City of Richmond
Urban Development Division

Report to Development Permit Panel

| Re: | General Compliance Request from Darsan Rangi for the Development Permit at 9191 Blundell Road | File: DP 02-202952 |

NEK MULTI-FAMILY RESIDENCE
 7800 HEATHER STREET
 RICHMOND, B.C.

TITLE
 ELEVATIONS

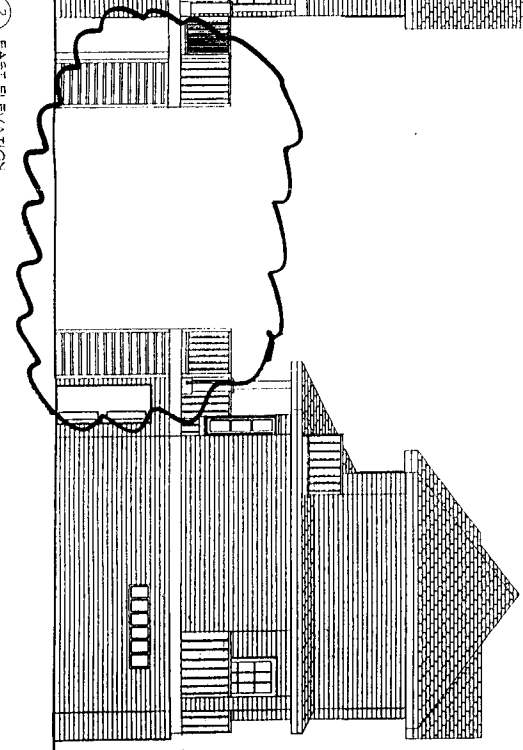
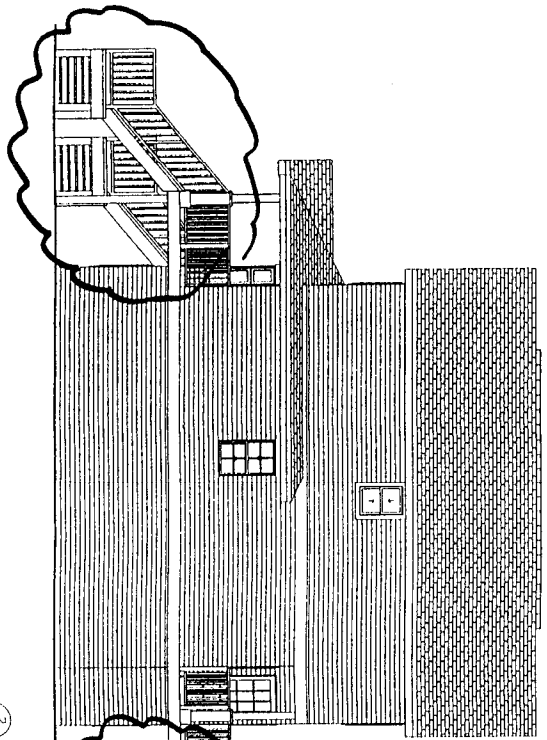
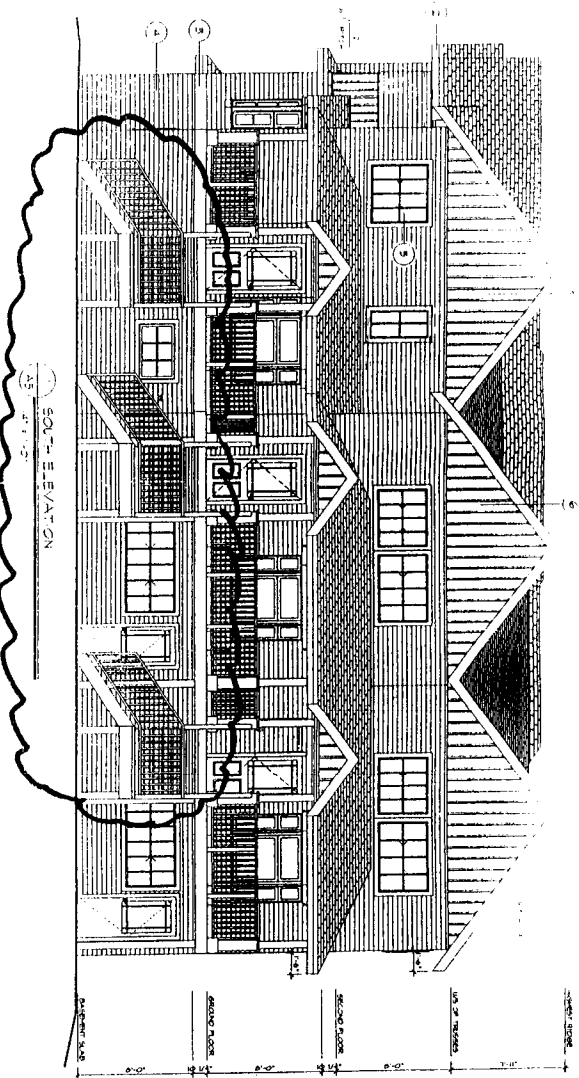
4. Proposed exterior modifications must maintain or enhance the quality of the development and must retain the basic form and character of the development. ***Replacement of the cedar siding with vinyl siding does not enhance the quality of the development.***

7. Proposed changes to the location and configuration of vehicle access and parking areas should be minor in nature. ***Complies.***
8. Proposed modifications must not contravene the applicable Development Permit Guidelines. ***Replacement of the cedar siding with vinyl siding contravenes the South McLennan Development Permit Guidelines.***

At their meeting of 14 May, 2003, the DP Panel referred this general compliance request to staff to report back on the issue of finish materials on buildings in the area. The development permit in this case called for cedar siding and the applicant wishes to change it to vinyl. For further analysis of the guidelines for General Compliance, refer to the staff report.

The guidelines for McLennan South call for natural finish materials. Although vinyl is not a natural material, it has been allowed when disguised and softened by the use of a lot of natural materials such as trim, brackets, etc. In the case of Mr. Rangi’s project the building does not have a lot of detailed character other than the cedar. Mr. Rangi has claimed that no-one is using cedar siding, but some projects are using cedar **shingles** as an accent material.

If vinyl is going to be substituted for the cedar siding, then hardi-plank or some other more durable material should be used on the lower 1/3 of the three-storey buildings, along with additional wood trim and details, such as cedar shingle gable ends.

SITE LANDSCAPING PLAN
SCALE 1/8" = 1'-0"

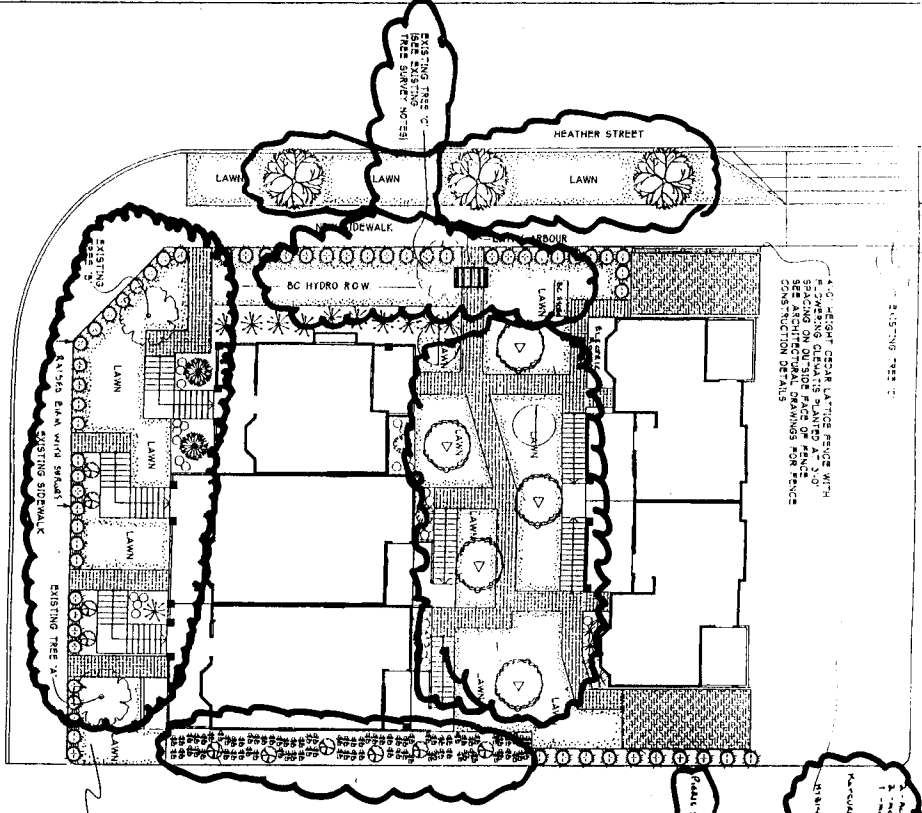
The applicant is also proposing to change the species and size of trees on the Heather Street boulevard. The Development Permit showed three 8 cm Raywood Ash trees, whereas the approved Servicing Agreement (SA 02-202854) called for three 8 cm Kousa Dogwood trees. The proposal now is to install three 5 cm Katsura trees on the Heather Street boulevard.

6. Approved open space and amenity areas should be maintained; proposed changes to landscaping detail should be minor in nature and of equivalent value to approved plans. ***The proposed tree species on Heather Street are governed by the Servicing Agreement. Staff can not support the proposed changes on Heather Street as a general compliance ruling. Similarly, the replacement of the one existing Colorado Spruce tree that was to be retained which inadvertently was removed should be replaced with two 10 cm calliper trees (not two 8 cm calliper Magnolia trees). The other landscaping changes are generally acceptable, although aren't really of an equivalent value.***

Darshan Rangi is proposing a number of changes to his approved Development Permit at 9191 Blundell Road. Some of these arise from the approved Building Permit, and others are new. Staff can support the majority of the changes as a general compliance request. However, staff are not in support of changing the siding from cedar to vinyl, the proposed trees on the Heather Street boulevard, or the size of the replacement trees for the one existing tree inadvertently removed.
